APPROVED
Limited building only review
Permit holder responsible for full compliance with the code

Revised floor truss to I Joist after plan approval. Approved revision 11/05/2021

The Redwood

Truss Placement Plan
SCALE: NTS

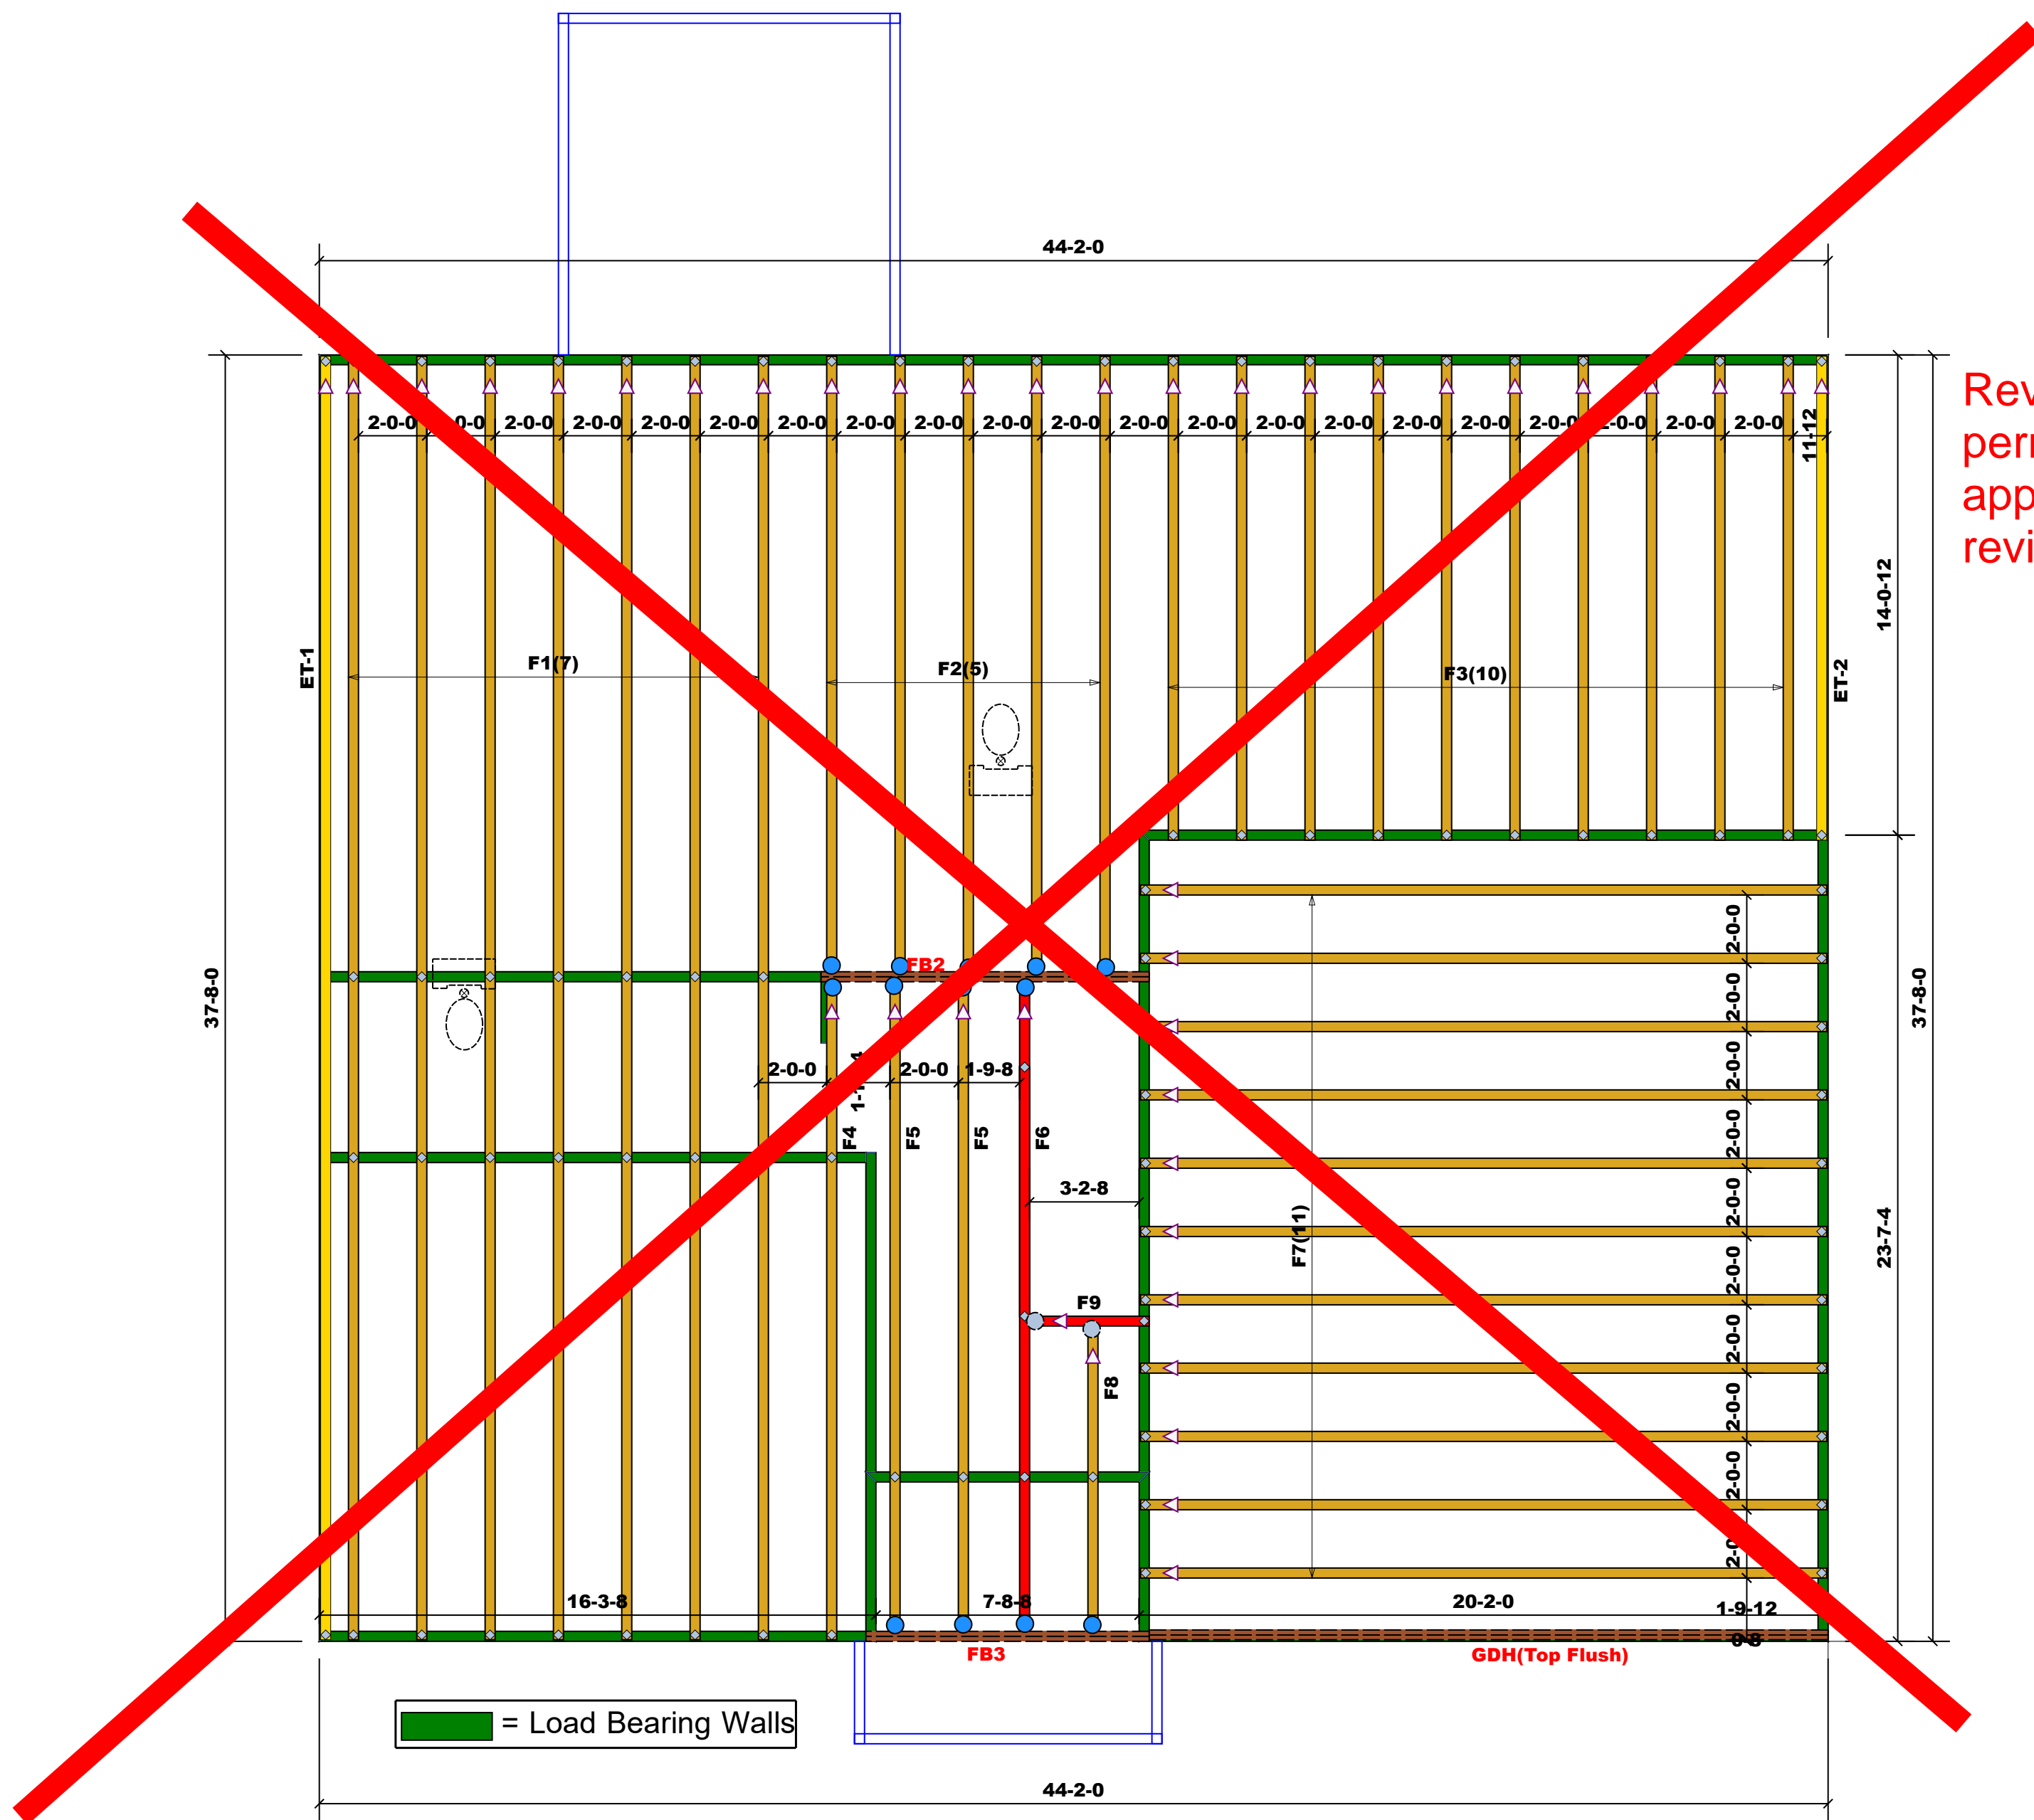
Revised to I joist after permit issuance/plan approval. Stop it. See revised layout.

Truss Placement Plan
SCALE: NTS

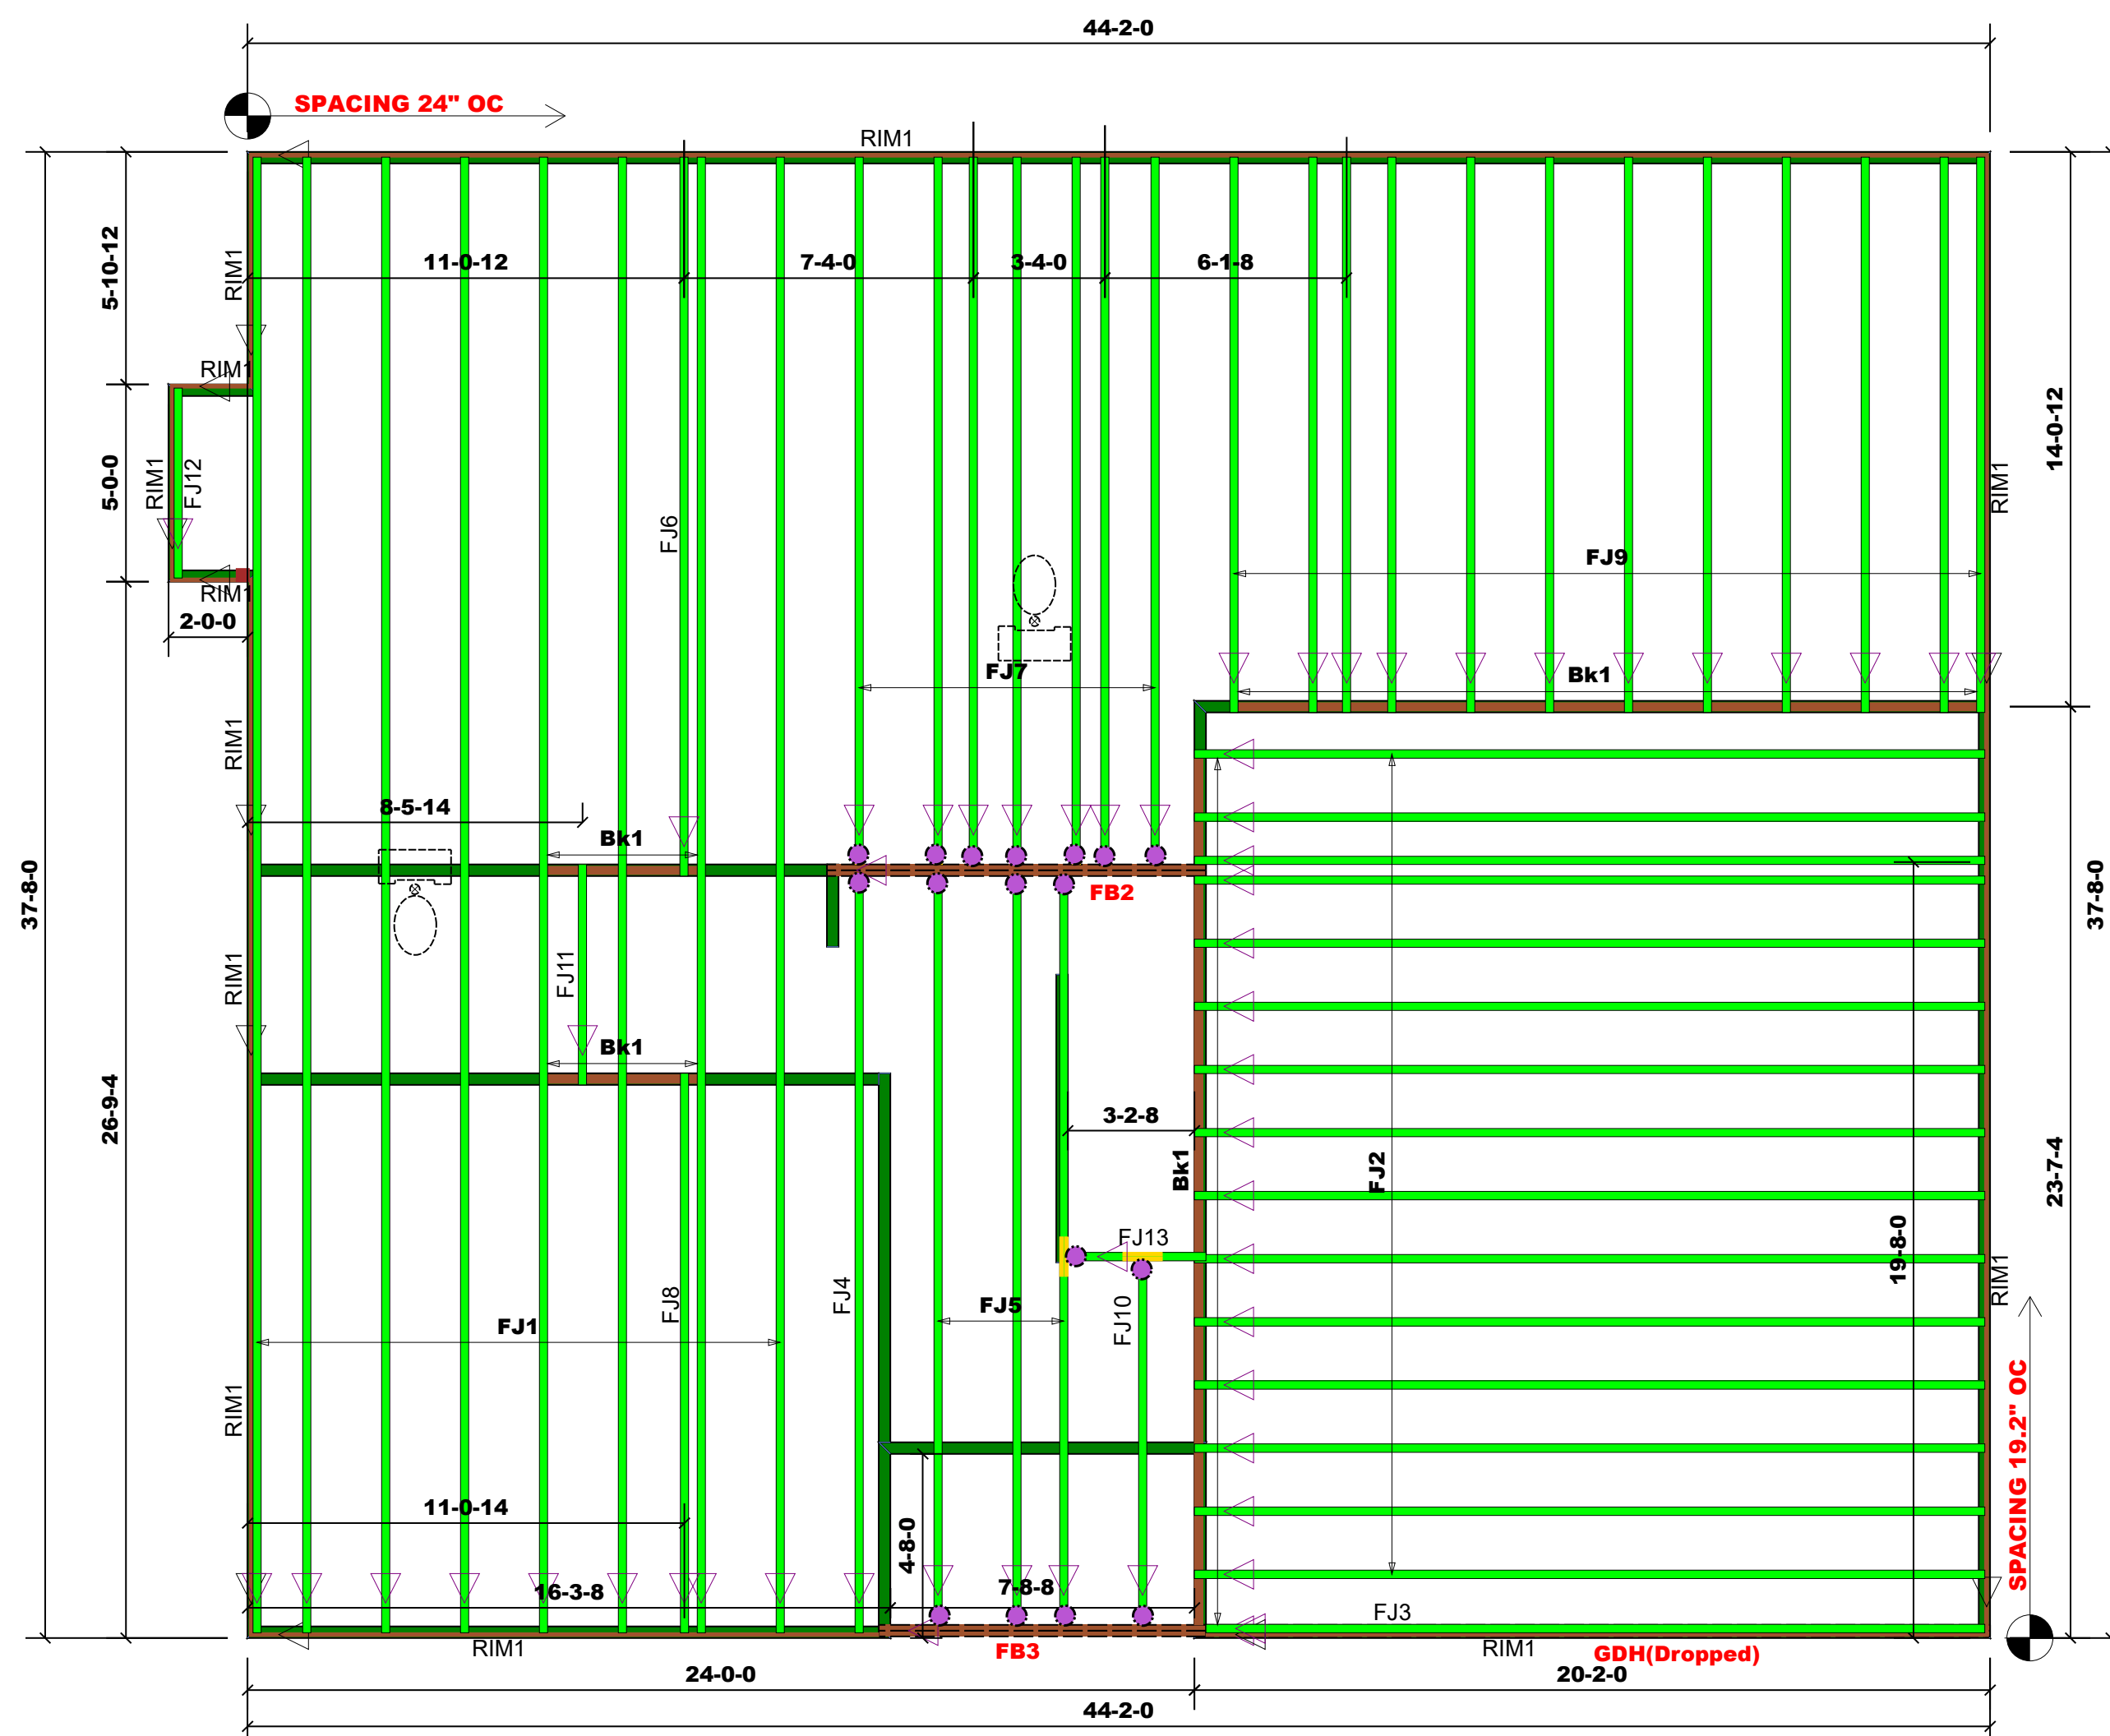
Revised floor layout. Approved 11/05/2021
